Saiham Knit Composite Ltd. (Extension Area)

Saiham Nagar, Noyapara, Madhabpur, Hobigonj
(24.18375, 91.35222)

Observations

Dampness throughout the building

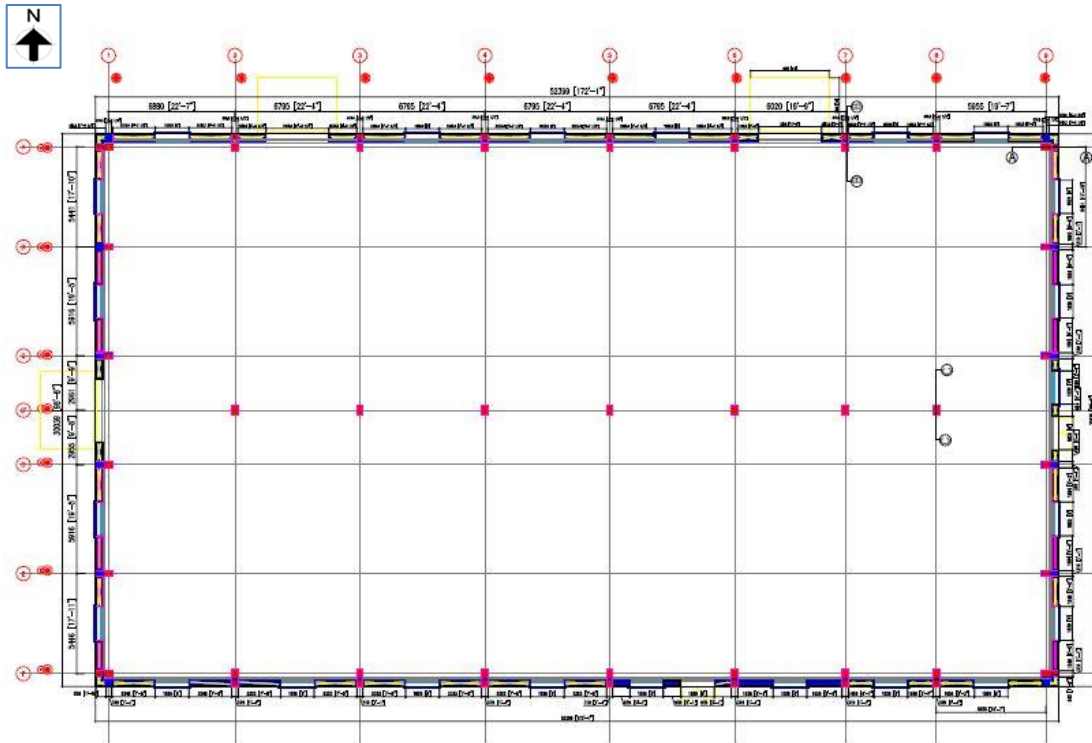
Dampness was observed through the building. Building engineer is required to investigate the reason of dampness and suggest remedial actions.

Laterally unsupported long columns

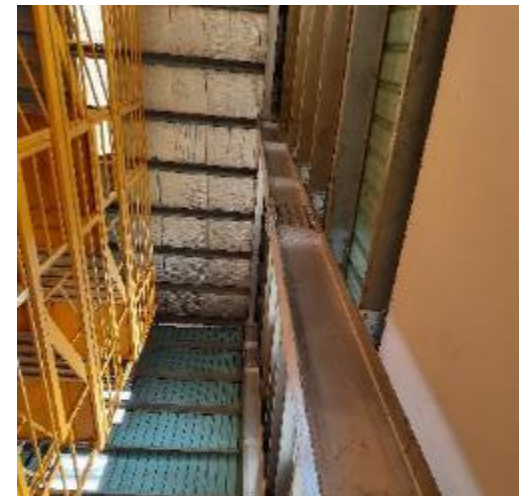
The 14.5 m long columns are not laterally supported along its weaker direction. Compression strut/tie beams are not provided in the intermediate position of these long columns. Building engineer is required to check the lateral stability of the shed.

Compression strut/tie beams not provided in the long direction

Design report not available

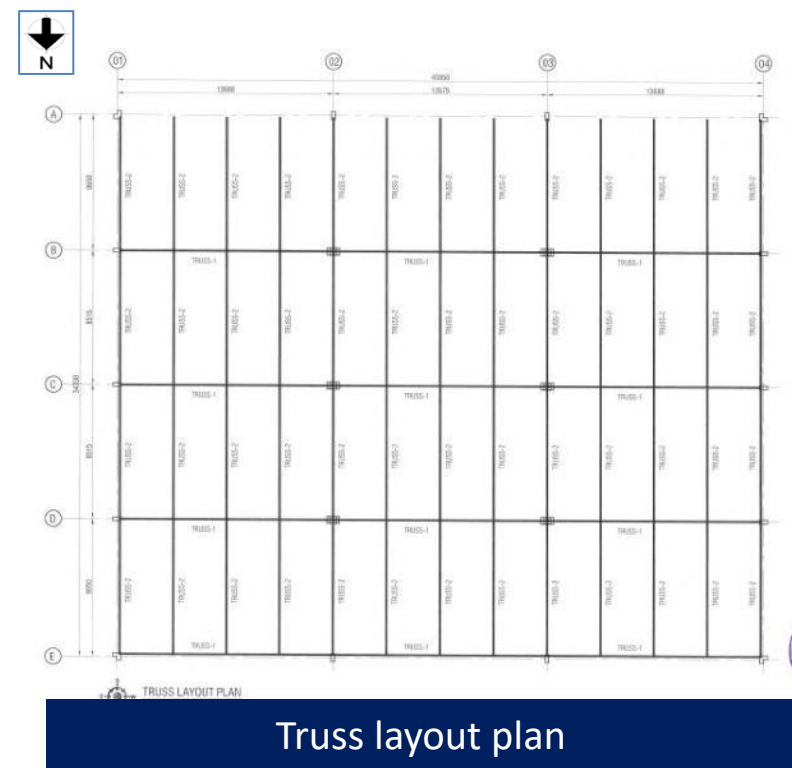
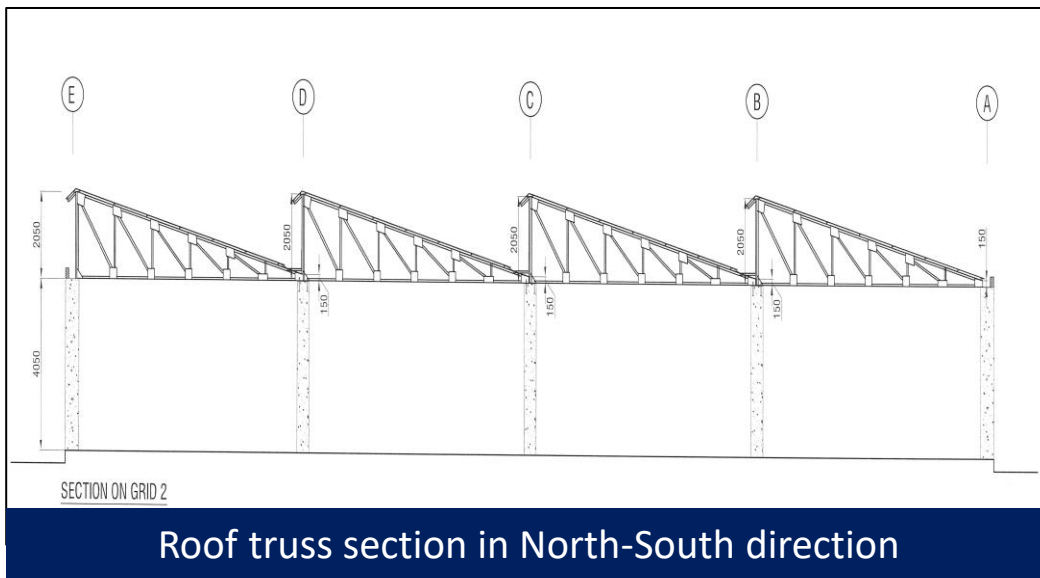
As per BNBC, every building or structure designed shall have its design documents prepared in accordance with the provision of Section 1.9.1. The design document shall include a design report, and a set of structural drawings, which shall be prepared in compliance with section 1.9.1.1 and section 1.9.1.2 as per BNBC. At the time of inspection, only a design certificate was available on site, but no design report was available which is required to be prepared in compliance with section 1.9.1.1 (part-6, BNBC).

Apparently lack of lateral stability system

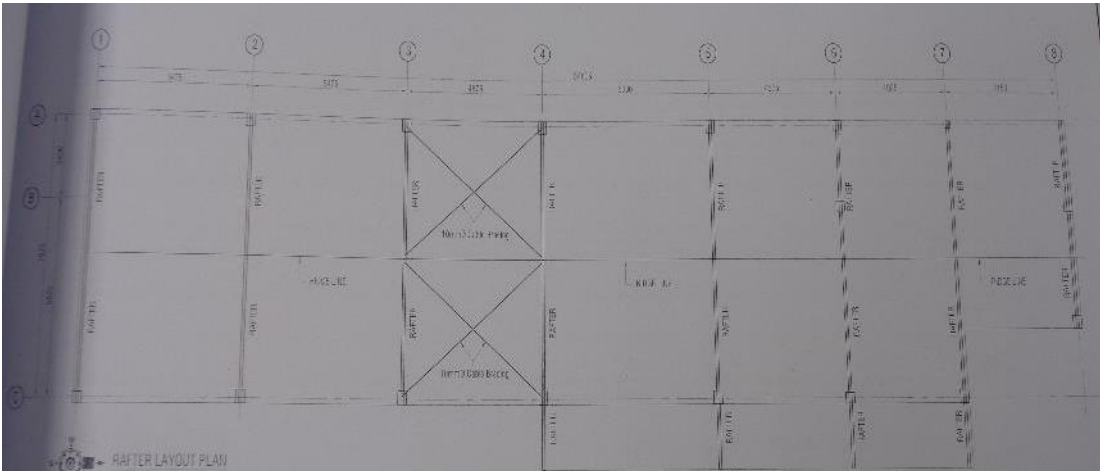
No bracings and compression members are provided in the roof level. The building engineer is required to check the lateral stability system of the shed.

As-Built documents not available

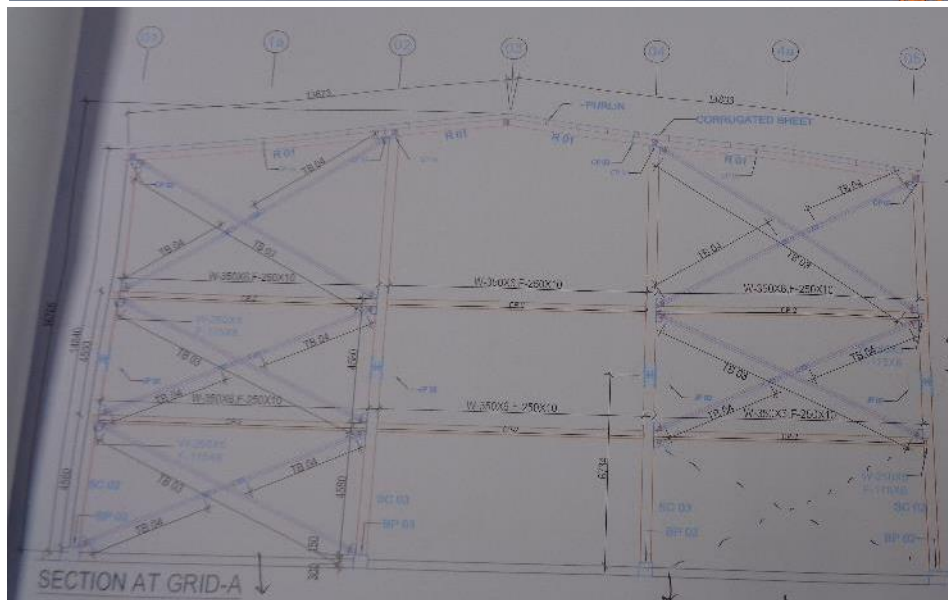
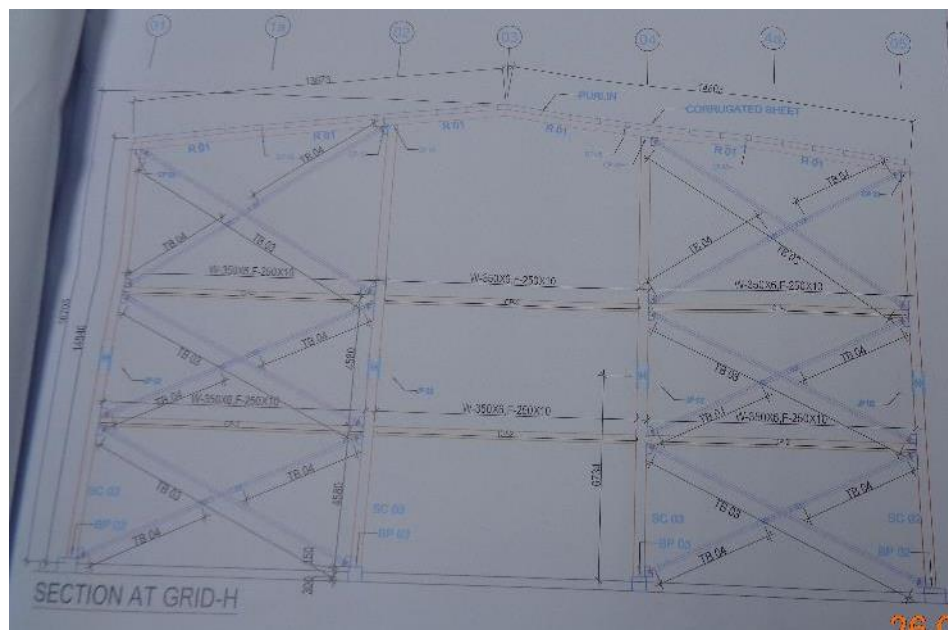
As per BNBC, every building or structure Designed shall have its design documents Prepared in accordance with the provision of Section 1.9.1 The design document shall include a design report, and a set of structural drawings, which shall be prepared in compliance with Section 1.9.1.1 and section 1.9.1.2 as per BNBC. No credible as built drawing were available on site. Building engineer is required to prepare design report in compliance with section 1 9 1 1 (part 6 BNBC)
